ADDENDUM NUMBER ONE

DATE: October 16, 2012

SUBJECT: Addendum Number One to
Manchester Road Streetscape Project Phase 2
Federal Project No. STP-5401(662)
Cochran Project No. SC10-229

LACLEDE GAS COMPANY -- ST. LOUIS, MO.

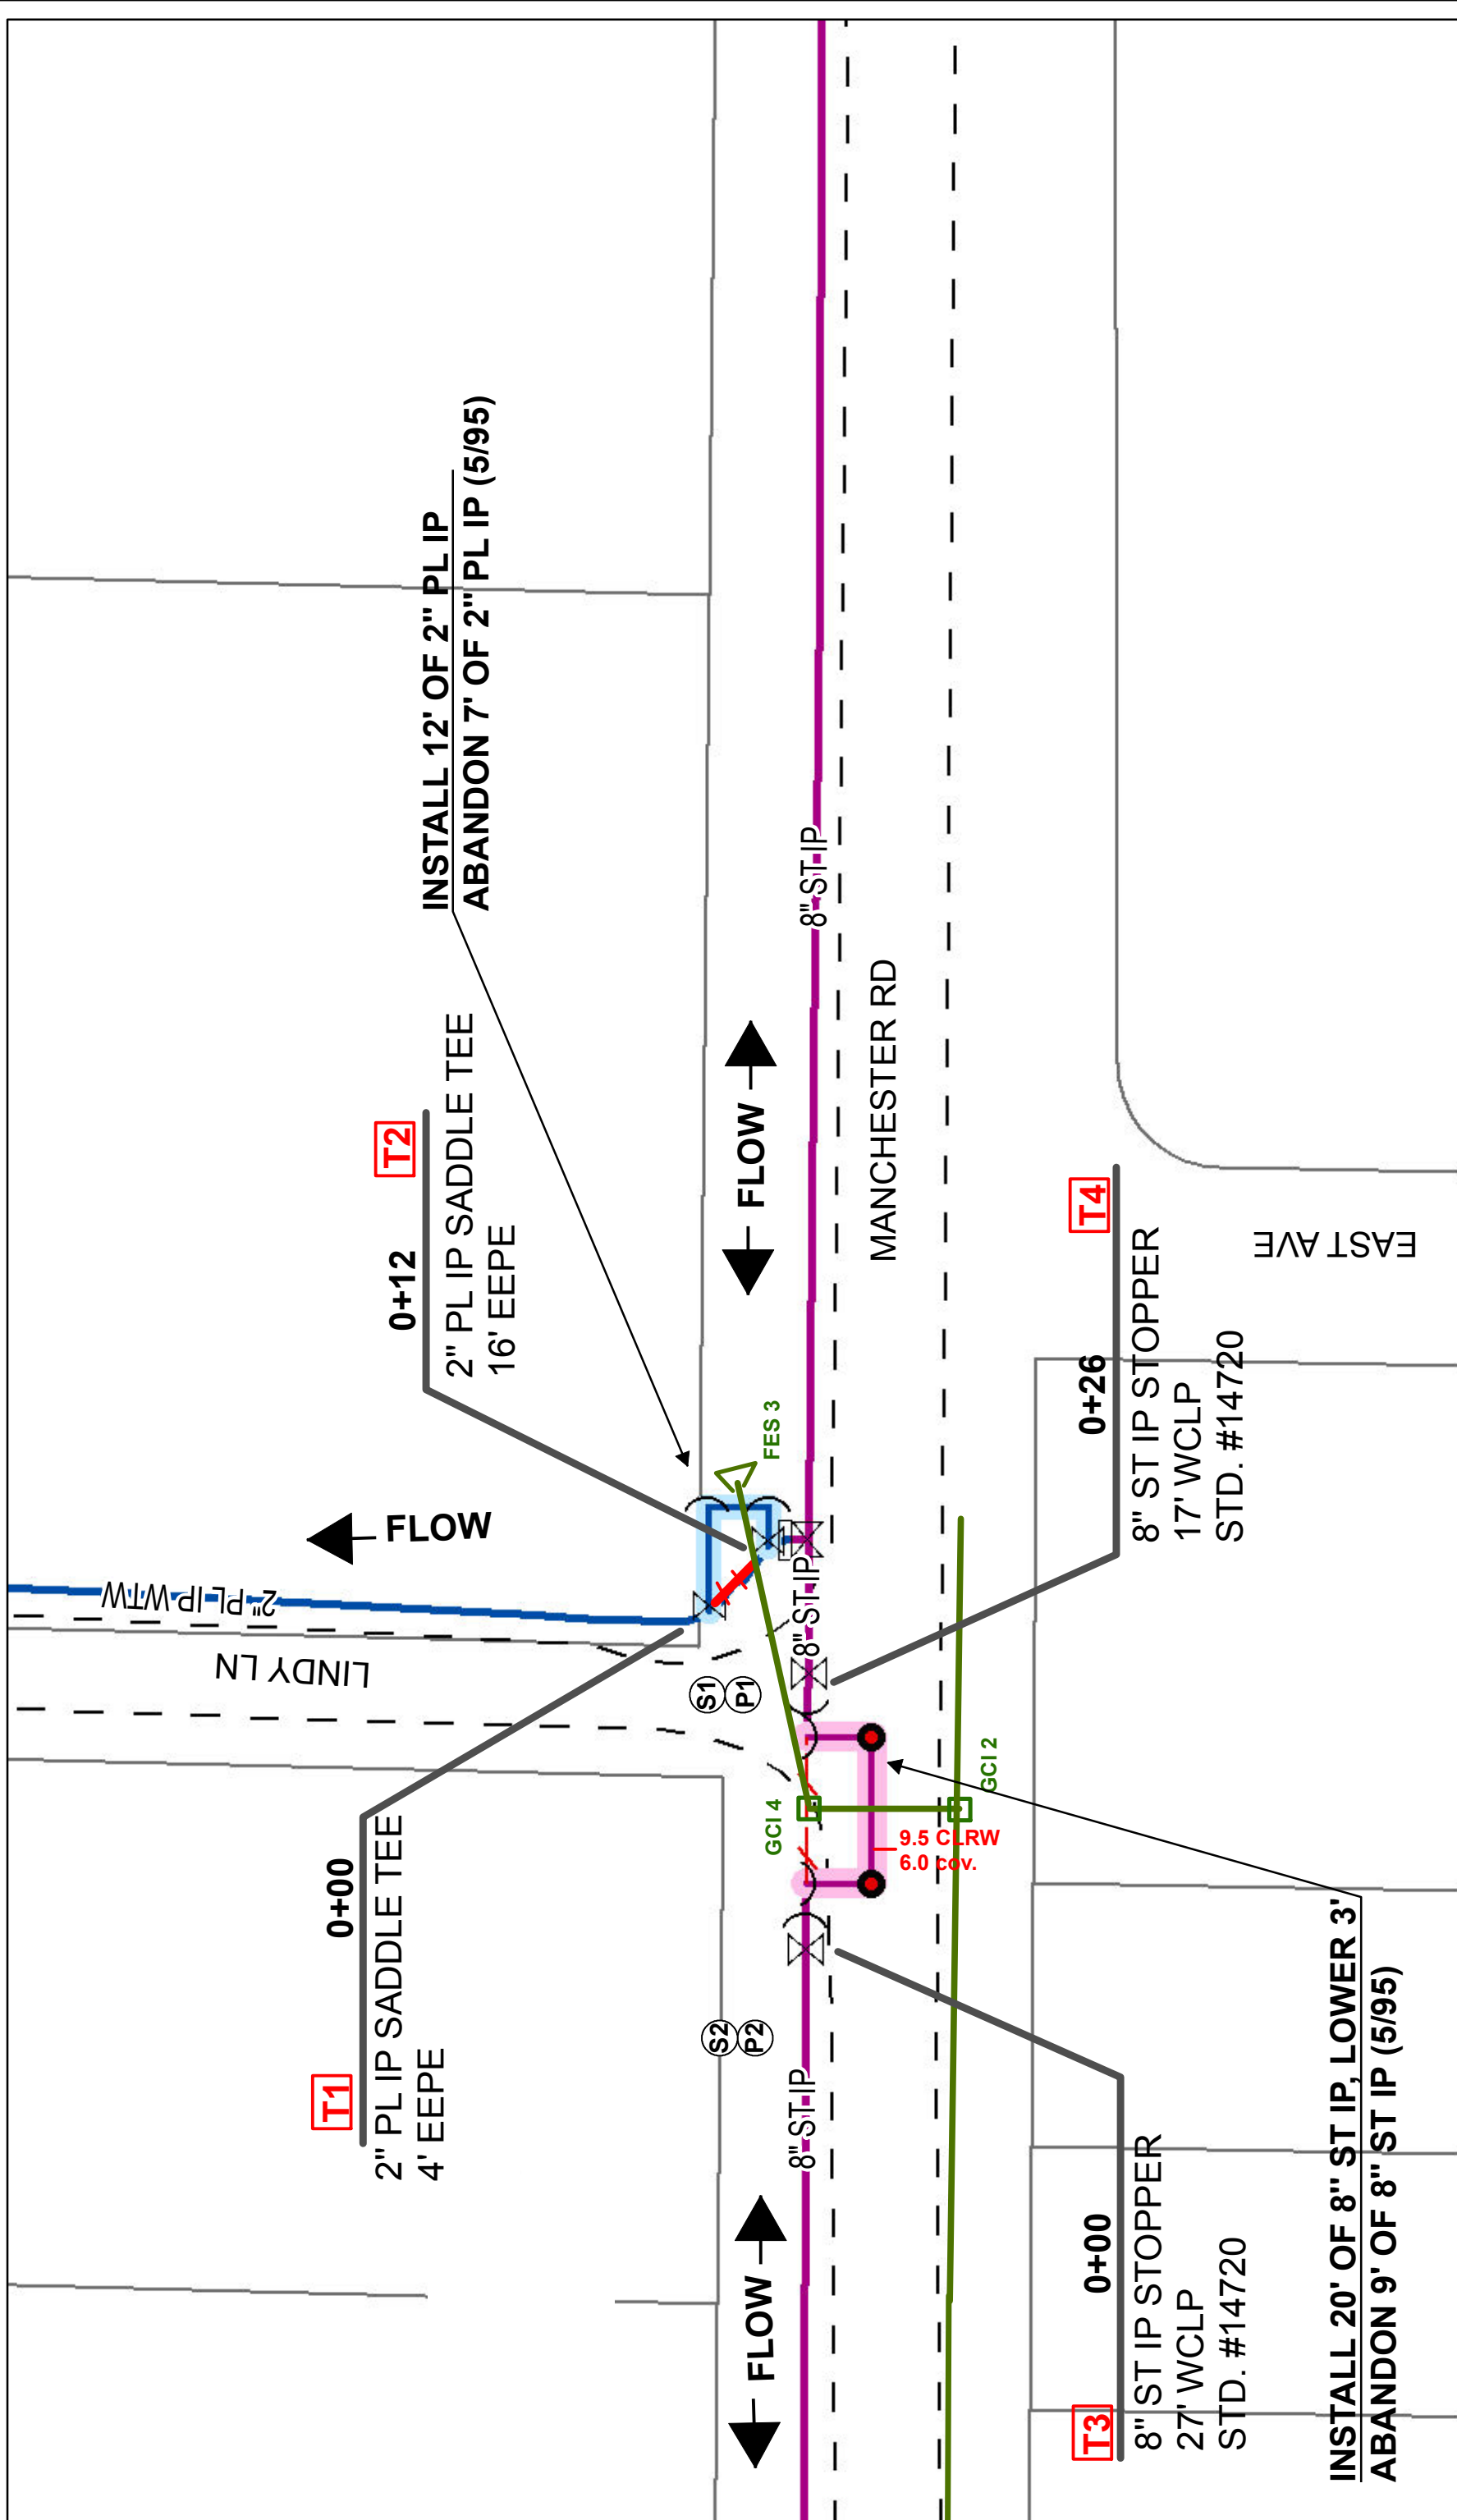
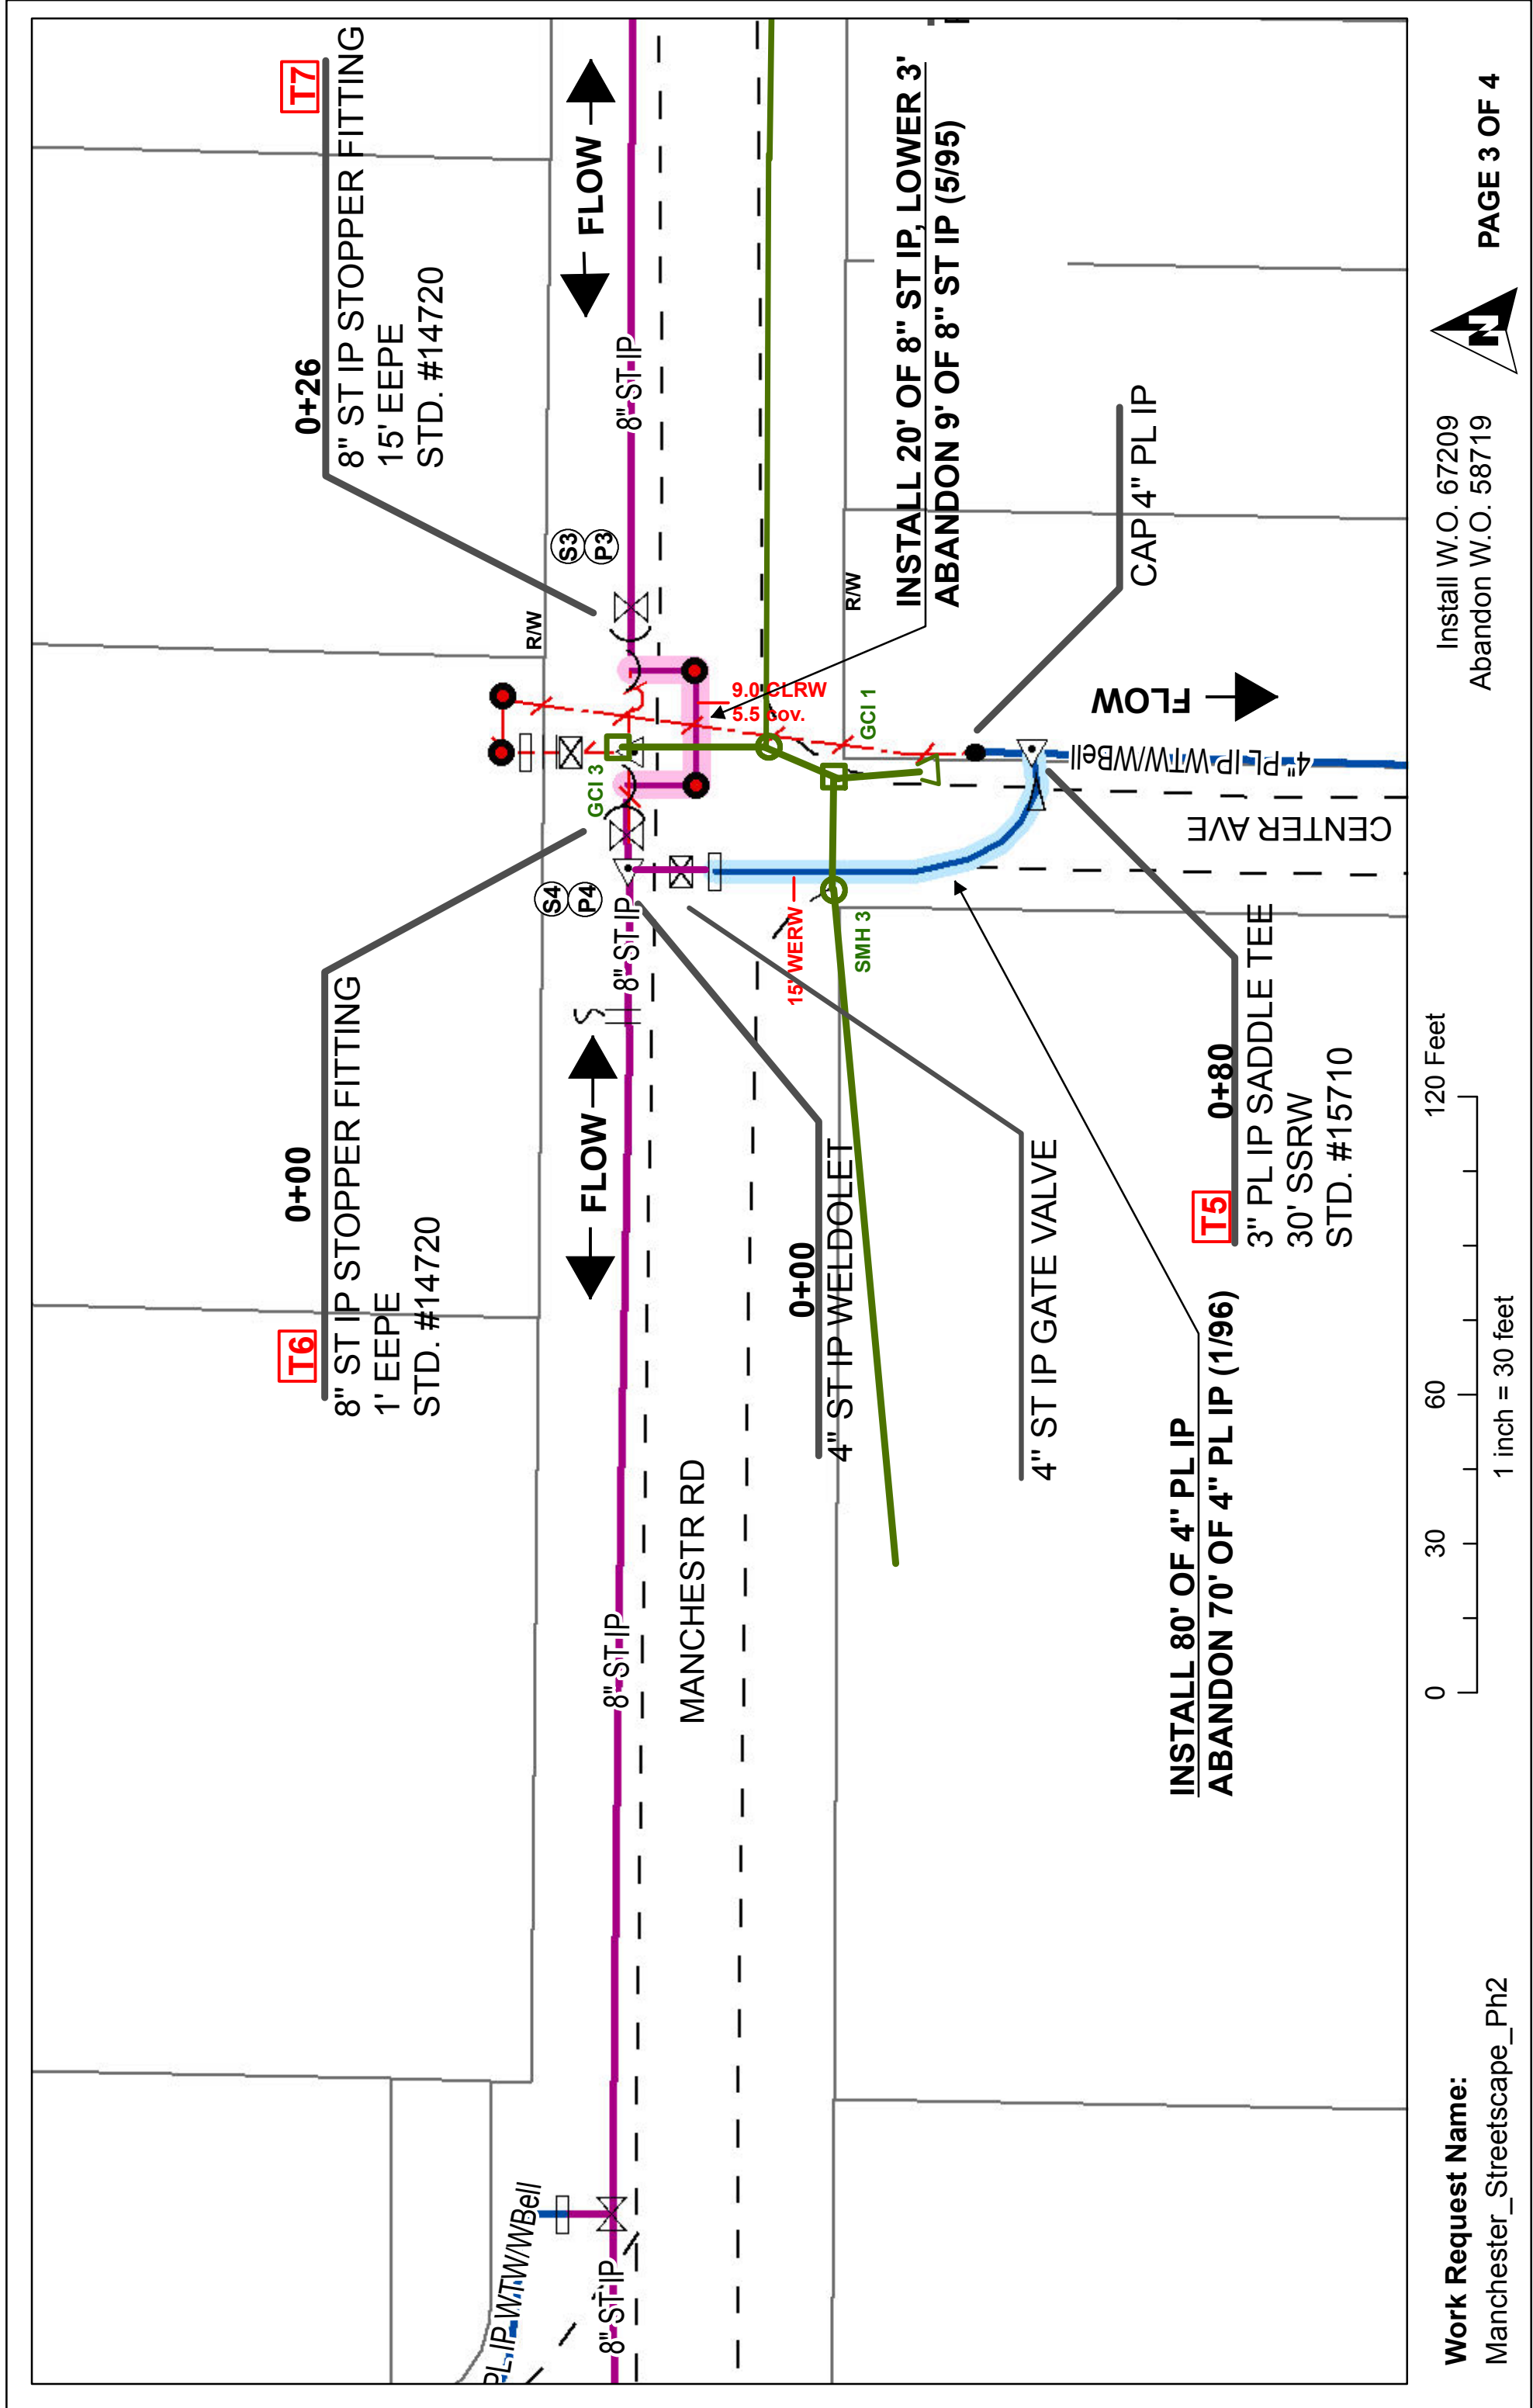
6. **CLARIFICATION:** On plan sheet ST-2, Storm Line 4 notes that the Contractor is to relocate the existing gas line. Laclede Gas will be responsible for moving all gas line conflicts. A copy of the Laclede Gas relocation plan has been included for informational purposes. Delays due to gas line conflicts are addressed in the Job Special Provisions.

INSTALL 20' OF 8" ST IP, LOWER 3'
ABANDON 9' OF 8" ST IP (5/95)
